Validation Report

Validation of the AWMS Methane Recovery Project BR06- S -20, Minas Gerais, Brazil

Report No. 842817, rev. 0

December 17, 2006

Annex 3: Pictures and drawings evidencing the distance between Granja Itajuba (PDD 25) and Granja Sao Francisco (PDD 20)

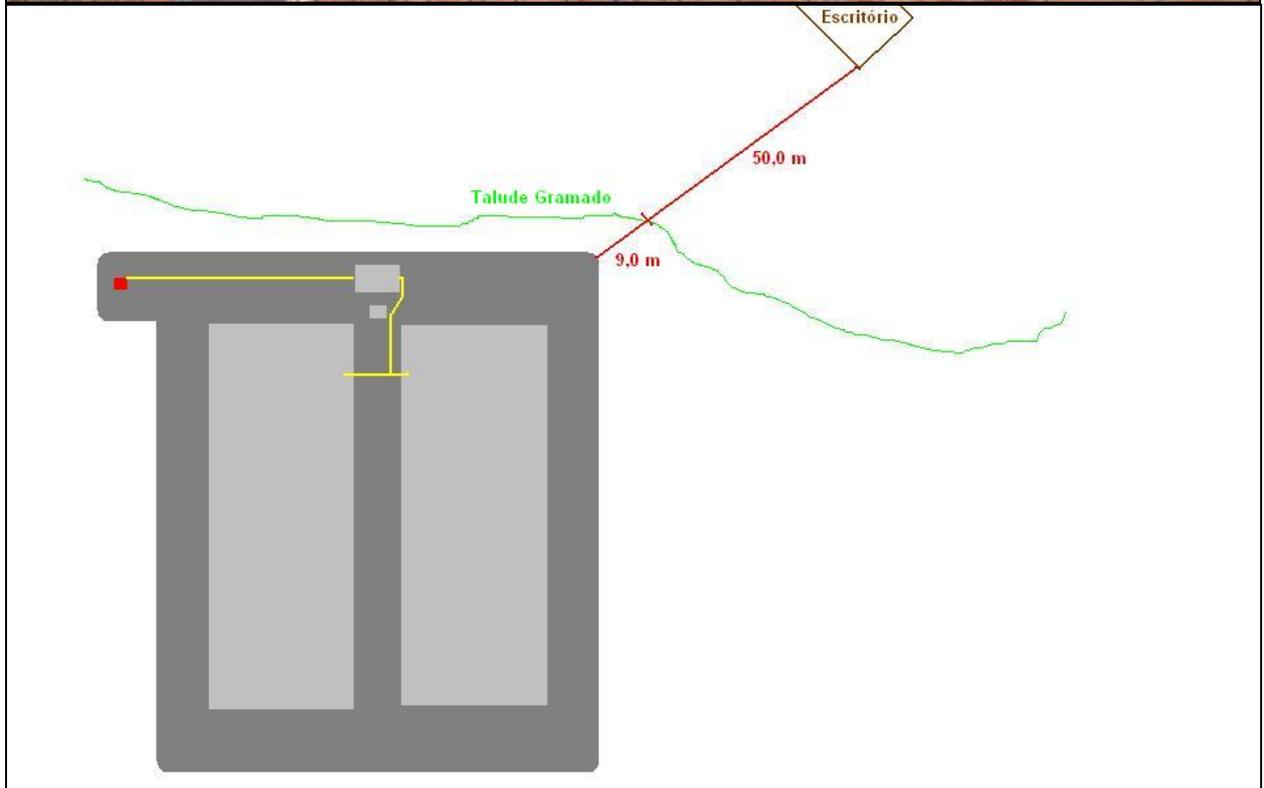
It has been identified one critical case for debundling. The farm “Granja Sao Francisco” is situated very close to farm “Granja Itajuba” from project BR 06-S-25. AgCert has to provide a very precise GPS data from the biodigestors of the farms and hence to evidence that the two biodigestors are situated more than 1 km from each other.

All projects are plotted using “Google Earth” to ensure locations are not creating a debundling issue. Precise GPS coordinates have been included in the last submitted PDD. These distances will be considered if at some time in the future AgCert is to build additional digester(s).

Farm Granja Itajuba (PDD 25) and farm Granja Sao Francisco of PDD 20 are proven to be more than 1 km apart, according to GPS coordinates taken from the farm, and the distance between the points where those coordinates were taken and the precise location where biodigesters are planned to be built. Evidences are in annex 3 (pictures and drawings).
